APPLICATION FOR A RESIDENTIAL SITE IMPROVEMENT PERMIT/ CONSTRUCTION AUTHORIZATION FOR AN ON-SITE WASTEWATER SYSTEM, NEW WELL INSTALLATION, OR REPAIR OF EXISTING WELL

PLOT PLAN
AT PROPERTY KNOWN AS
#1621 HART ROAD
LOT 12, BLOCK 'D', RIVERHAVEN
PARCEL ID # 031-213-01, DB 34035 PG 56
PAW CREEK TOWNSHIP, MECKLENBURG COUNTY, NC
FOR: ROGER LEON

Re: Application for improvement permit for: 3 Bedroom House
Property Location: 1621 Hart Rd, Charlotte, NC 28214 (PID 031-213-01)
Health Department File Number: **14490 (App ID 13200)**

SOIL/SITE EVALUATION
for ON-SITE WASTEWATER SYSTEM

Sketch of Soil Evaluation Locations

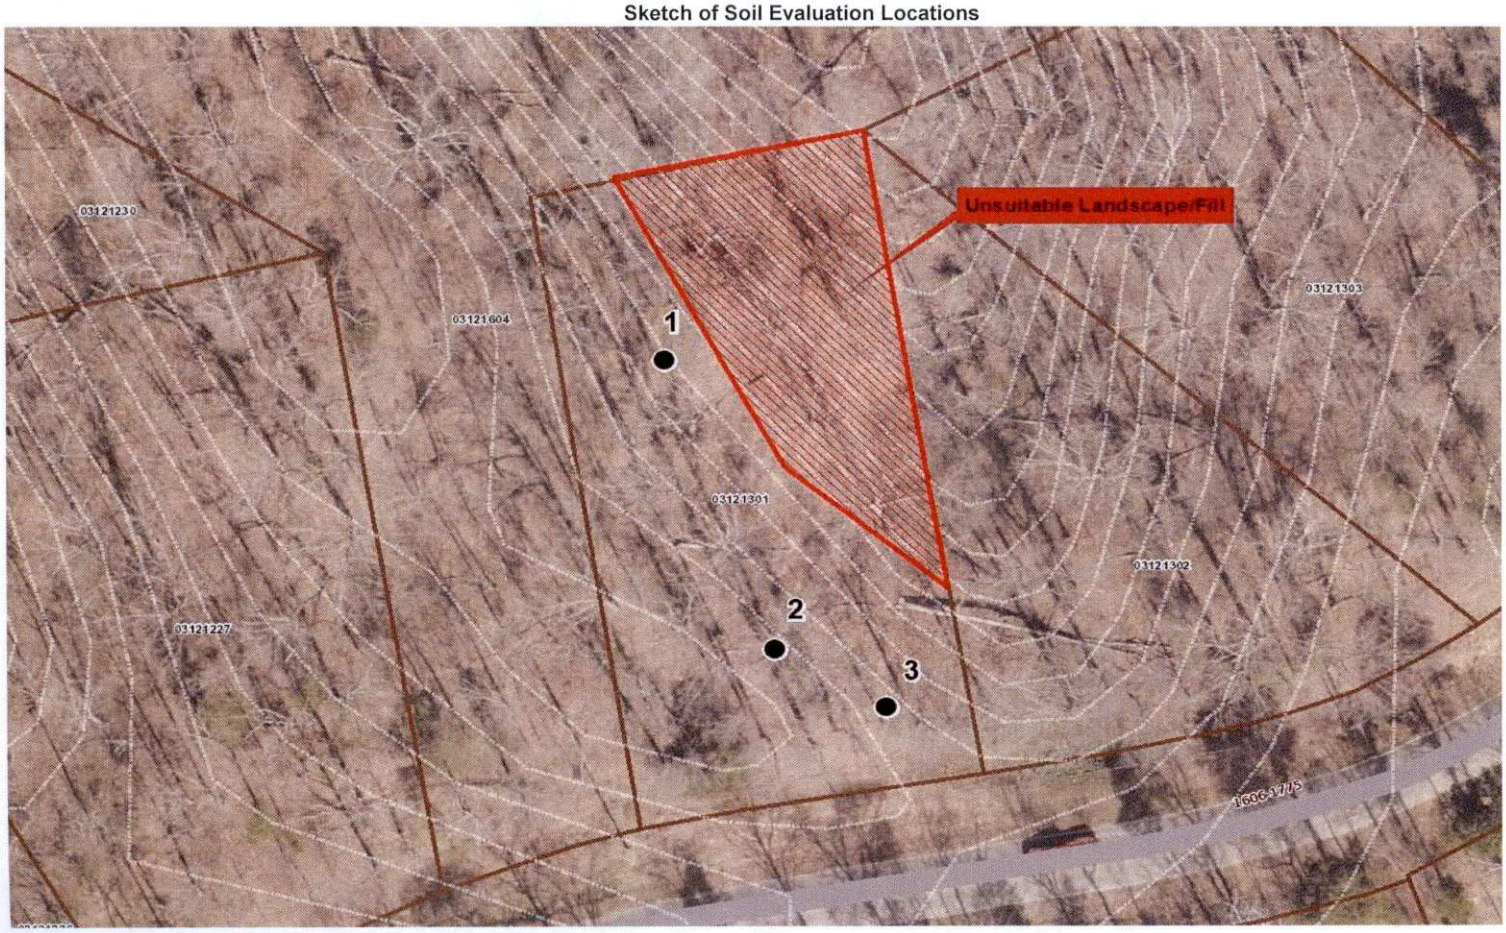
Based on the criteria set out in Title 15A, Subchapter 18A, of the North Carolina Administrative Code, Rules .1940 through .1948, the evaluation indicated that the site is **UNSUITABLE** for a ground absorption sewage system. Therefore, your request for an improvement permit is **DENIED.** A copy of the site evaluation is enclosed. The site is unsuitable based on the following:

- ☒ Unsuitable soil topography and/or landscape position (Rule .1940)
- ☐ Unsuitable soil characteristics (structure or clay mineralogy) (Rule .1941)
- ☒ Unsuitable soil wetness condition (Rule .1942)
- ☒ Unsuitable soil depth (Rule .1943)
- ☐ Presence of restrictive horizon (Rule .1944)
- ☒ Insufficient space for septic system and repair area (Rule .1945)
- ☐ Unsuitable for meeting required setbacks (Rule .1950)
- ☐ Other (Rule .1946)

PROFILE #	.1940 Landscape Position/ Slope%	Horizon Depth (IN.)	SOIL MORPHOLOGY .1941 .1941 Structure/ Texture	.1941 Consistence Mineralogy	b PROFILE FACTORS .1942 Soil Wetness/ Color	.1943 Soil Depth (IN.)	.1956 Sapro Class	.1944 Restr Horiz	General Comments	Profile Class & LTAR	Maximum Trench Bottom Depth for 3' Wide Conventional Trench
Pit #1	LS 8%	0 - 28	Fill	NA							
		28 - 44	mass CL	S SP FI/VFI SEXP	>44"	0	US	NA		**US**	**NA**
Pit #2	LS 2%	0 - 48	mass SCL	S SP VFI SEXP	10YR 6/1 at 41" at root channel	0	US	NA		**US**	**NA**
Pit #3	LS 2%	0 - 48	mass SCL	S SP VFI SEXP							
		48 - 55	mass SL/SCL	SS SP FI/VFI SEXP	>55"	0	US	NA		**US**	**NA**

Description	Initial System	Repair System
Available Space (.1945)	US	US
System Type(s)	NA	NA
Site LTAR (gpd/sq ft)	**US**	**US**

Other Factors (.1946):
Soil Evaluation By: Jacob Presley, LSS, REHS
Others Present:
Site Classification (.1948): Unsuitable
Site Evaluation By: Jacob Presley, LSS, REHS
Others Present:

However, the site classified as **UNSUITABLE** may be classified as **PROVISIONALLY SUITABLE** if written documentation is provided that meets the requirements of Rule .1948(d). A copy of this rule is enclosed. You may hire a consultant to assist you if you wish to try to develop a plan under which your site could be reclassified as **PROVISIONALLY SUITABLE.**
